ADDENDUM

Client: VIT CUSD #2
 Project Name: Sanitary Piping Replacement
 Project Number: 6741
 Addendum Number: 1
 Issued: 04/06/2026

This addendum becomes a part of the bidding and contract documents and modifies the drawings and specifications dated March 27, 2026. Acknowledge receipt of this addendum by noting such on the Contractor's Proposal (Bid) Form.

EXAMPLE OF CORRIDOR FLOORING
SHOWING ~12-18" DARK SOLID BORDER
WITH FLAKE PATTERN IN THE MIDDLE

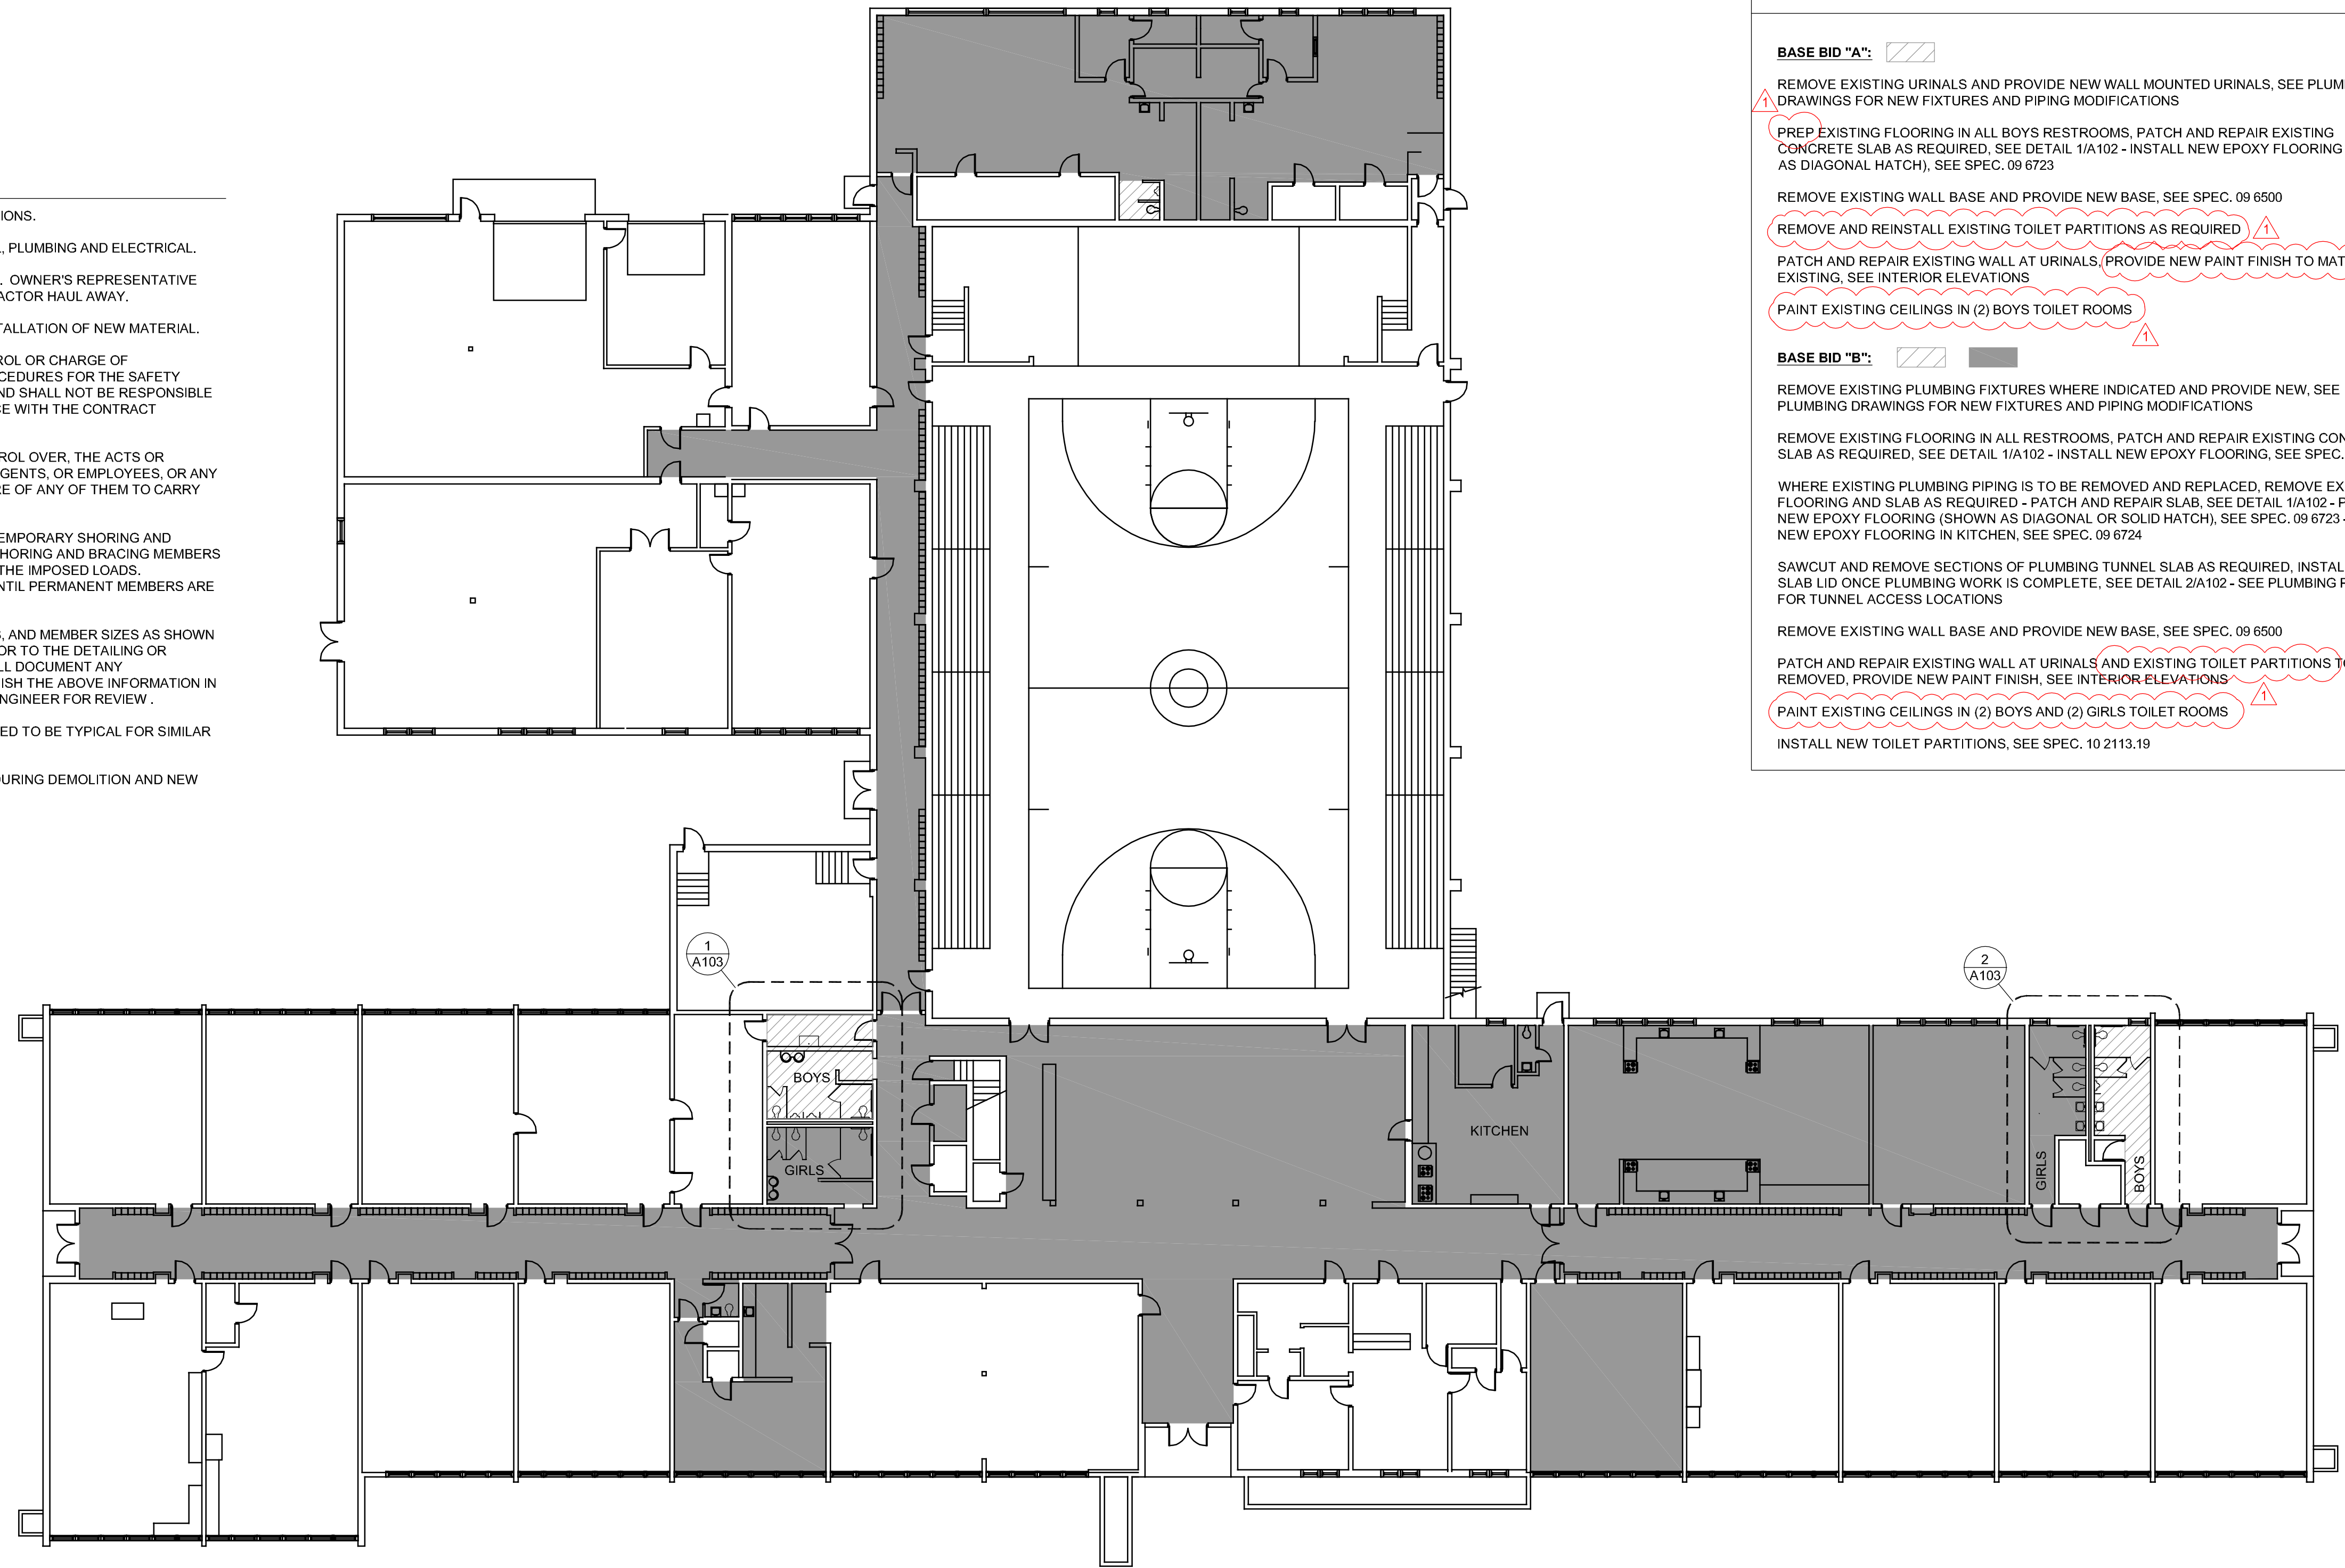
ITEM	DESCRIPTION	NOTES
GENERAL		
The link below contains original plans and recent camera sewer videos.		
https://architechnicsinc1-my.sharepoint.com/:f:/g/personal/imiller_architechnicsinc_com/IgBupHdunMOft6-nAh61z-4WAZEyEerr06cDPH5fERii4-4?e=AZPMzw		
Project Schedule	Clarify	If Base Bid "A" or "B" are awarded it is expected that the contractor will complete all work in the Summer of 2026. If Base Bid "C" is awarded this work could take place during the Summer of 2026 or 2027.
Casework	Add	Remove and reinstall existing casework as required for replacement of under floor sanitary piping.
Corridor Flooring	Add	Please see the attached picture of a layout/pattern similar to what the district wants for any new corridor flooring. Final layout/colors will be approved by the owner. This patter is for the corridors only. Any other areas will be flake or similar throughout.
